*Proceedings of the Madras Government, Public Works Department,
24th August 1864.*

No. 506. Read the following letter from the Consulting Engineer, Irrigation and Canal Company :—

Report on the Sunkasala Ancient and Head Works, and on the }
1st to 8th Sections of the Main Canal, &c., &c, inspected } (Here enter 2nd July 1864; No. 40.)
between the 30th May and 30th June 1864.

No. . Read the following letter from Captain J. MULLINS, R. E., Consulting Engineer for Irrigation and Canal Company, to Colonel C. A. ORR, R. E., Secretary to Government, Department of Public Works, dated Madras, 2nd July 1864, No. 40 :—

Sunkésala Anicut.

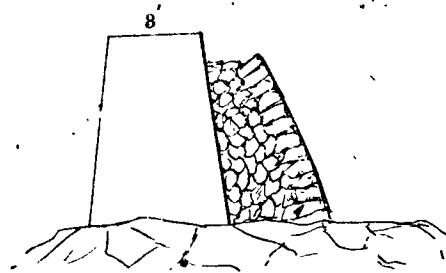
3. Both branches have been completed to their full height, no gaps remain, and that which formerly existed at the north end of the north branch has been closed by altering the line of the extreme end of the Anicut, in the direction of a more favourable ledge of rock, and raising across the deep channel a wing-wall of rubble masonry, which is connected with a mass of rock on the river bank, which rock forms a favourable termination, and will effectually prevent damage by the river turning the end of the work, should the northern embankment at any time give way. The wing is founded on a mass of rough stone.

4. Regarding the Anicut itself and the way in which it has been built, much need not be said here. General Ludlow, in paragraph 4 of his letter, alluded to the way in which the crown had been finished, and it has already been found necessary to repair parts, and it is clear that a crown composed of small irregular rubble stone is ill-fitted for such a position. All the rubble
